**CITY OF TEMPE**  
**DEVELOPMENT REVIEW COMMISSION**

Meeting Date: 06/23/2015  
 Agenda Item: 4

**BACKGROUND INFORMATION:** SOUTHBANK LOT 6 (PL140463) is a mixed-use project proposed within the Southbank development formerly known as The Pier at Town Lake. The building is six stories high (seven including mezzanine) and 88,118 total square feet in area. The request includes the following:

**01 SITE PLAN**  
SCALE: 1:30

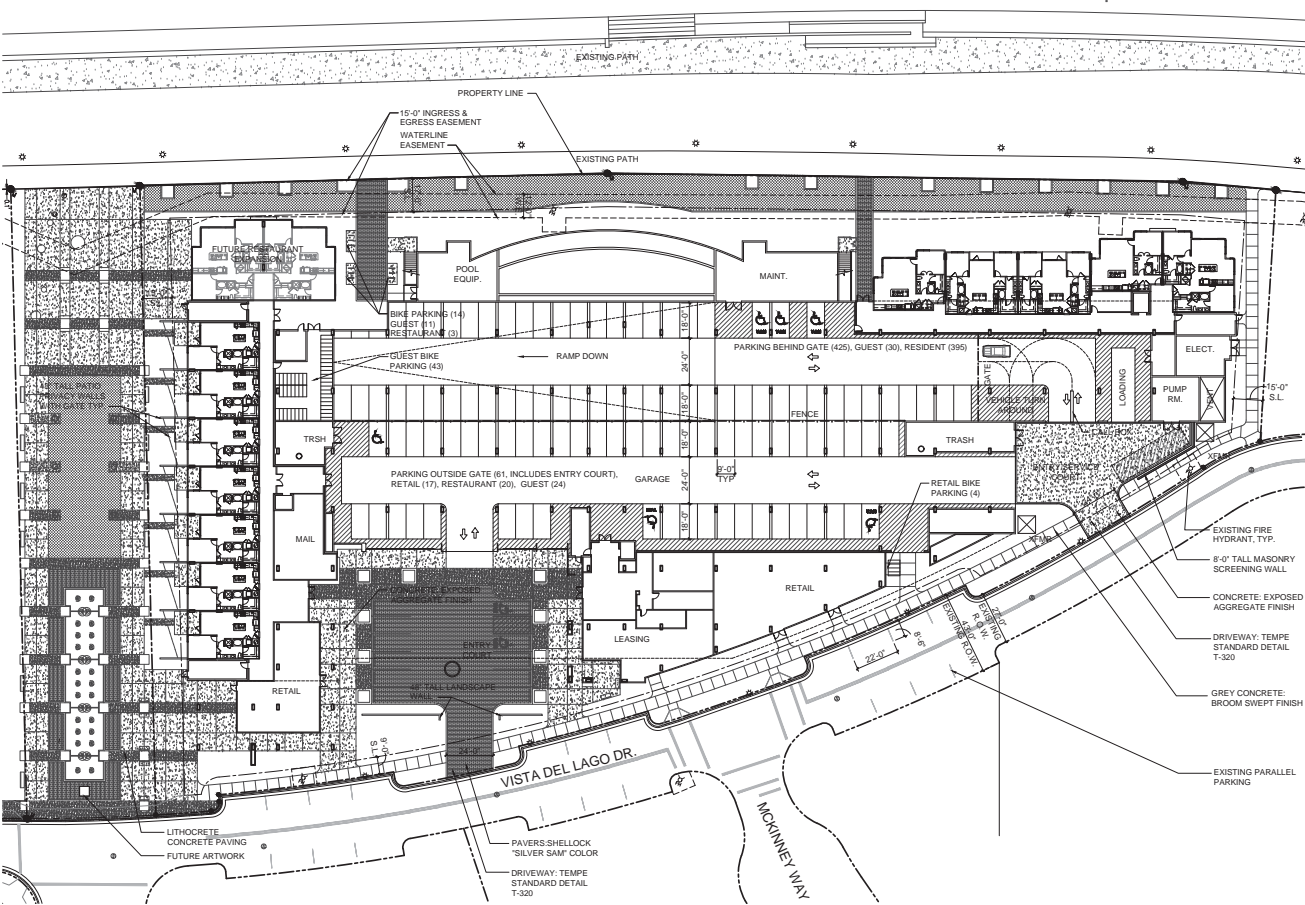
A "seepage recovery well maintenance easement" exists at the northwest corner of the property. Public Works must approve either the relocation or abandonment of this easement, or the site design must be modified.

The proposed landscape plans identify Southern Live Oak and Mulga Acacia along Vista del Lago Drive, which is not consistent with the original streetscape plan. As this is on the south side of the building, the approved Fan-Tex Ash trees would provide a wider tree canopy and better shade for pedestrians. Oleander trees are proposed within the parking court; while these trees are not ideal for shade, the court is surrounding by a five-story building on the north, west, and east, which will shade it for the majority of the day. Within Tract B, the applicant proposes Chinese Pistache, Date Palms, artificial turf, decorative paving, a shallow water feature, and a pedestal noted for future art. A condition is included to replace the artificial turf with grass for use by residents and visitors and to receive approval for the art.

The plan indicates “turf” on the north side of the building but uses the same symbol as the artificial turf in Tract B. A condition is included to require this turf to be replaced with either grass or crushed rock and ground cover plants. Desert Museum Palo Verde trees are proposed along the north side of the building; tree planting within the levee will require approval from the Maricopa County Flood Control District. To maintain views from the pool deck to the lake, the plan shows no trees between the building and lake for the approximately 140’ length of the pool. A condition is included to add trees on the north side of the multi-use path.

The original “garden commons” landscape area on the east side of the building has been significantly reduced to account for the proposed building setback. The area within the 15’ east building setback now includes a 5’ wide sidewalk and Southern Live Oak trees planted adjacent to the east property line. A condition is included to modify the landscaping within an increased building setback to create a usable open space.

4. The Public Works Department shall review and approve the abandonment or relocation of the existing well easement at the northwest corner of the property. The future Development Plan Review application shall reflect the existing or relocated easement. Final easement location is subject to the Public Works Director.

31. Modify the landscape plan to note the turf areas on the north side of the building as grass or replace with crushed rock and vegetative ground cover.

32. Add minimum 1.5" caliper size Desert Museum Palo Verde trees on the north side of the multi-use path.
33. Modify the landscape area between the building and east property line to include bench seating and shade trees and/or shade structures.

1 South Overall Elevation  
 SCALE: 1/32" = 1'-0"

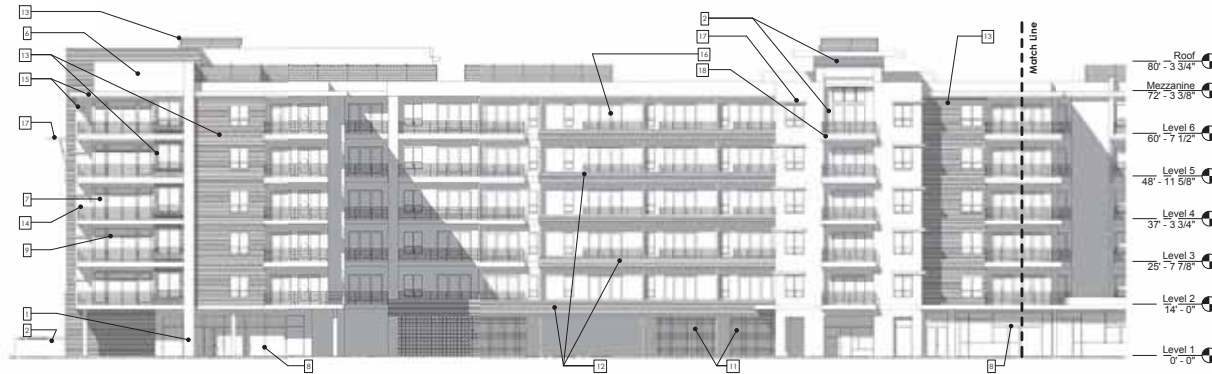
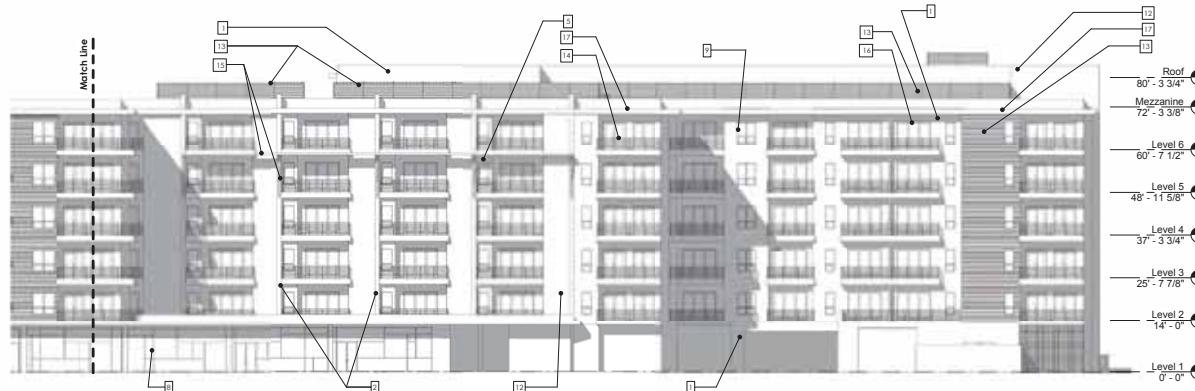
3. *Materials are of a superior quality, providing detail appropriate with their location and function while complementing the surroundings*; the main building materials (stucco and galvanized metal) are not of superior quality. Staff recommends that other exterior materials are used to create a building that is more modern and consistent with the quality expected of lakefront developments.

5. *Large building masses are sufficiently articulated so as to relieve monotony and create a sense of movement, resulting in a well-defined base and top, featuring an enhanced pedestrian experience at and near street level*; the building is a large mass that covers the majority of the lot. Excluding the two garage entrances, there is only one break in the building at the pedestrian level: near the northwest corner of the building where bike racks are located. Along the north elevation, the wall below the pool deck is blank with a stucco finish. The landscape plan also excludes trees in front of the pool deck, creating an unshaded and unwelcoming area for pedestrians along the lake. The project’s ground-floor lacks permeability and places for active and passive activities. The design does not energize the pedestrian level, either interior to the development or along the lake.

6. *Building facades provide architectural detail and interest overall with visibility at street level (in particular, special treatment of windows, entries and walkways with particular attention to proportionality, scale, materials, rhythm, etc.) while responding to varying climatic and contextual conditions;* design elements include recessed balconies and metal shade trellises. Enhanced materials and architectural details would increase the interest of the building.

- 18. Provide alternative building materials and colors, subject to further review by the decision-making body.
- 19. Provide primary building colors and materials with a light reflectance value of 75 percent or less.
